***Amendments to the Drawings***

***Remarks***

**FIG. 1**

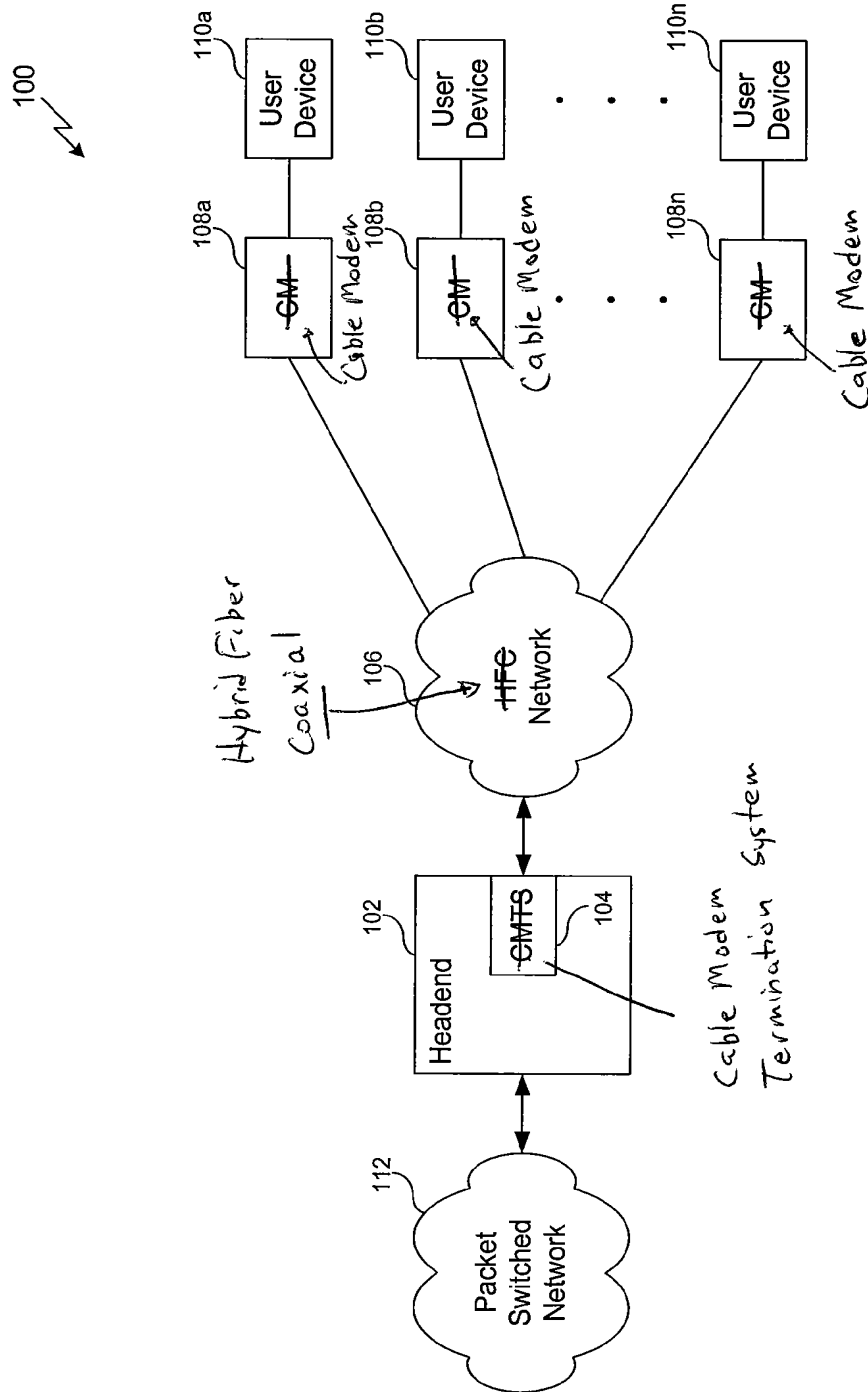
The attached sheets of drawings include changes to FIGs. 1, 2, and 4A-4C. These sheets replace the original sheets including FIGs. 1, 2, and 4A-4C. In FIGs. 1, 2, and 4A-4C, undefined acronyms have been removed in response to the Examiner's objections. FIG. 4C has also been amended to correct a clerical error.

On page 2, the Examiner objected to the drawings because FIGs. 1, 2, 4A and 4C do not have a descriptive legend of the acronyms CMTS, HFC, CM, SDRAM, and NCO. Although suitable legends “may be required by the Examiner where necessary for understanding of the drawing” (37 C.F.R. § 1.84), Applicants respectfully disagree with the Examiner’s position with regard to the particular legends referred to in the action.

However, in the interest of expediting prosecution, Applicants have amended the drawings to overcome the Examiner’s objections, with the exception of “SDRAM.” Support for the amendments may be found, *inter alia*, at the aforementioned paragraphs defining the acronyms. Applicants have not defined the term SDRAM in the figures (in addition to the aforementioned definition in the specification) since this term is well known in the art.
